Project: IEEE P802.15 Working Group for Wireless Personal Area Networks (WPANs)

Submission Title: CSK related Comment Resolution Input Summary

Date Submitted: 17. May 2010

Samsung response about CSK comment

- Figure 40 – CSK system

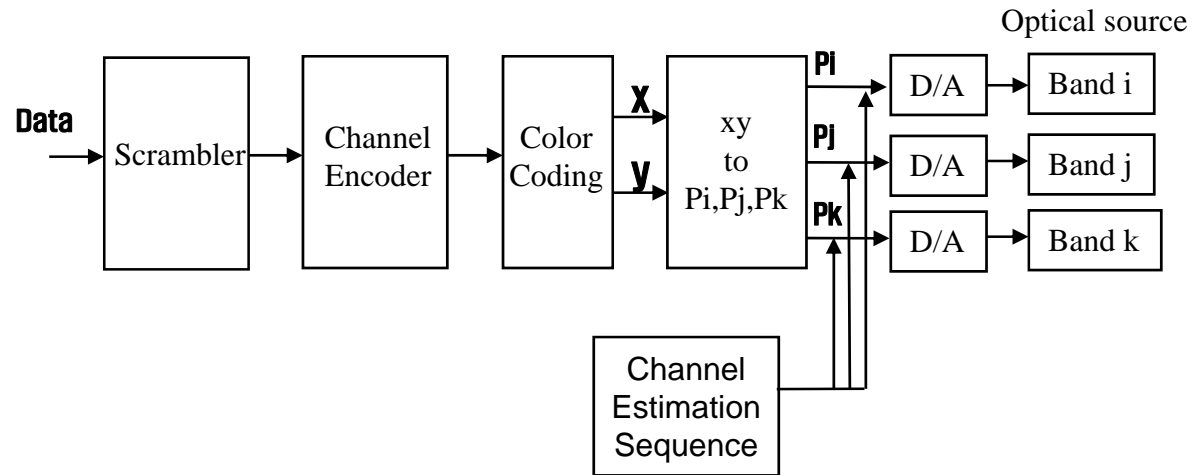
CID 399

- Figure 44 – Color Calibration

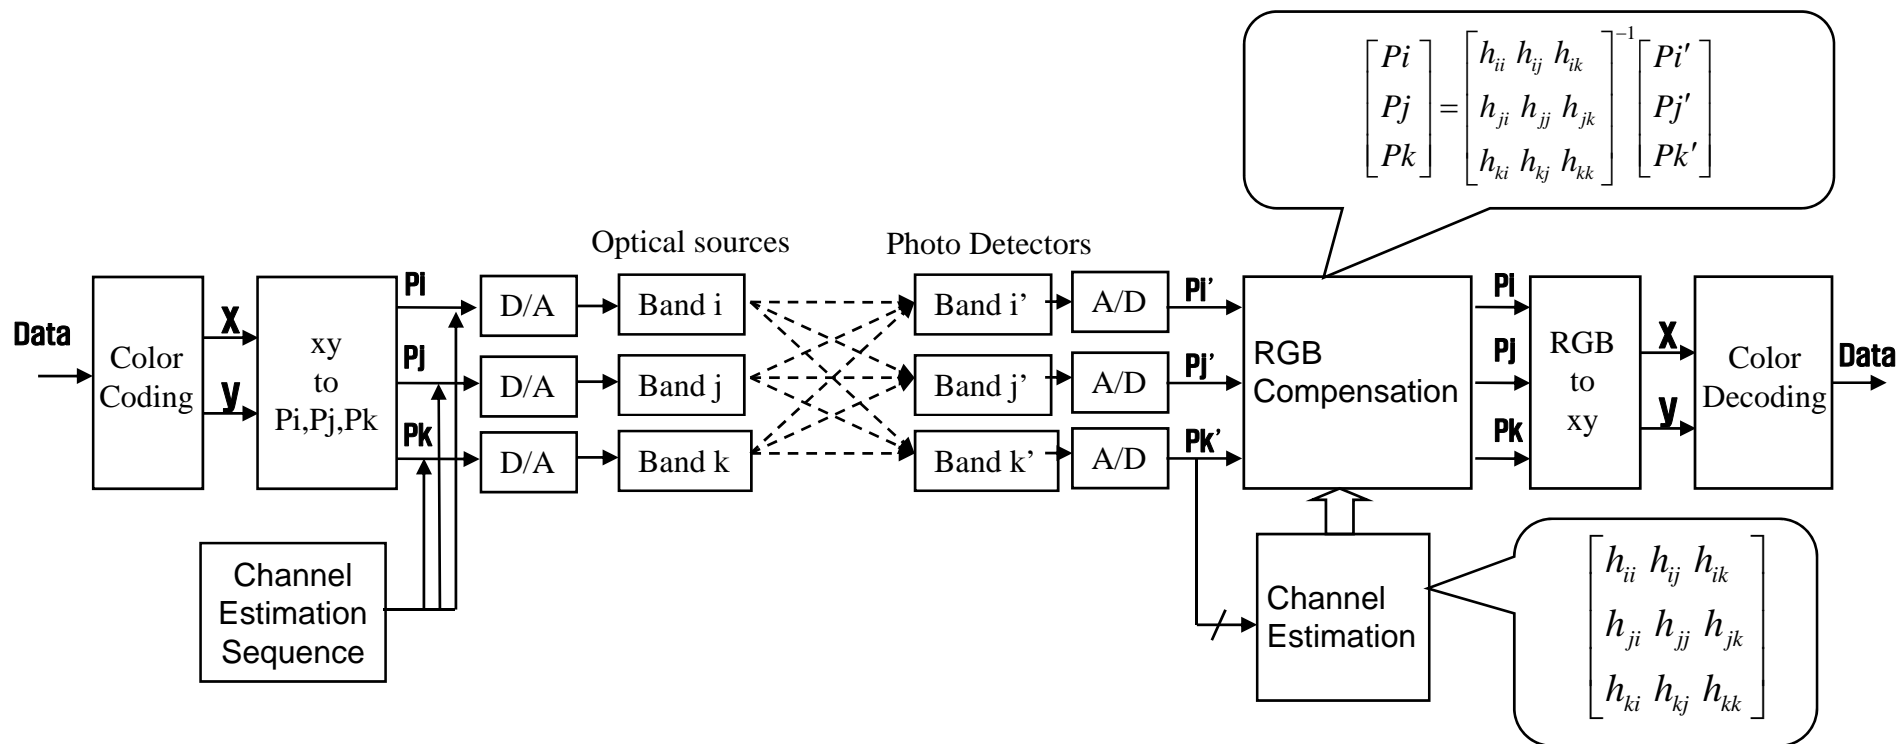
CID 404, 405

- Figure 39 – Color constellations for CSK

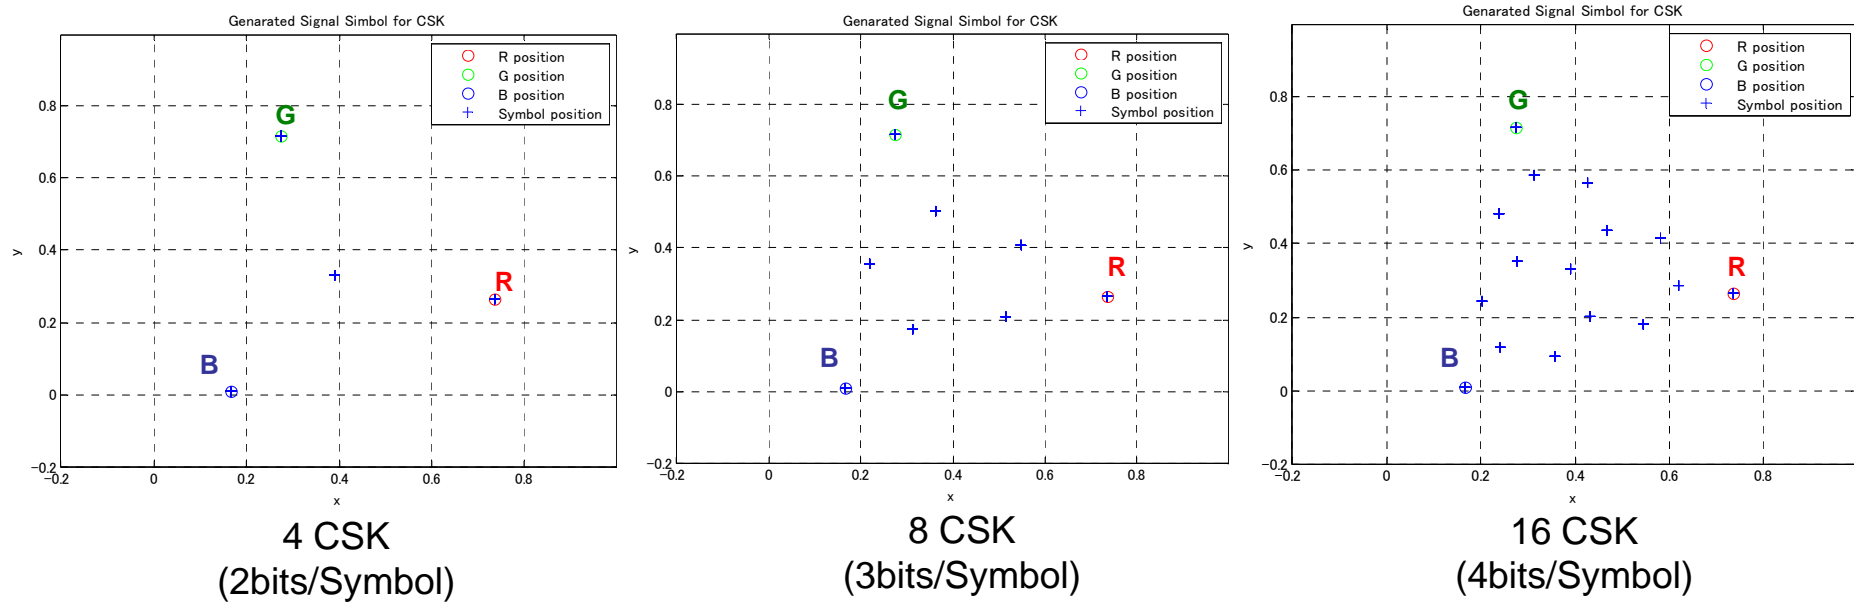
CID 873

- Figure 41 – CIE 1931 xy color coordinates

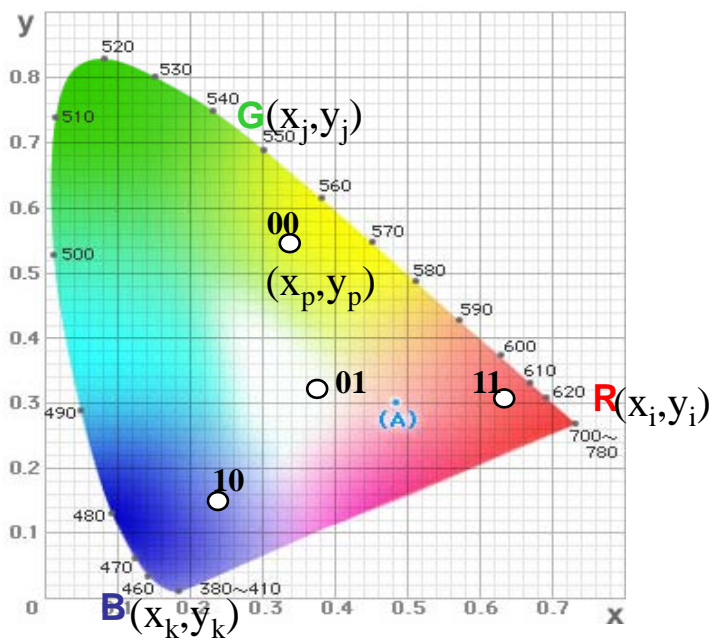
CID 879

$$x_p = P_i \cdot x_i + P_j \cdot x_j + P_k \cdot x_k$$

$$y_p = P_i \cdot y_i + P_j \cdot y_j + P_k \cdot y_k$$

$$P_i + P_j + P_k = 1$$
